SERVICE MEMORANDUM

DOOR LOCK CABLES

MGA TWO-SEATER

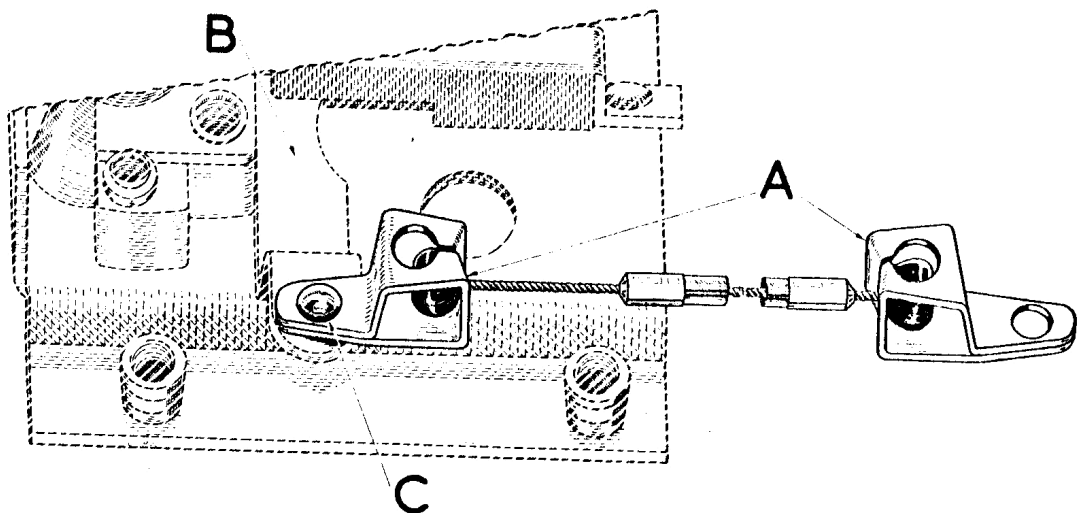
The method of attaching the door lock cable to the lock lever has recently been improved. All replacements will be to the new pattern (Part Nos. are unchanged),

The modified cable incorporates two end-brackets 'A' in place of the original clinch-straps. One end-bracket is secured to the door lock lever 'B' by a 3/16" diameter rivet 'C'. The opposite end is fixed to the cable door bracket by the existing nut and bolt.

N.B. The rivet 'C' is not serviced and is thus a local supply.
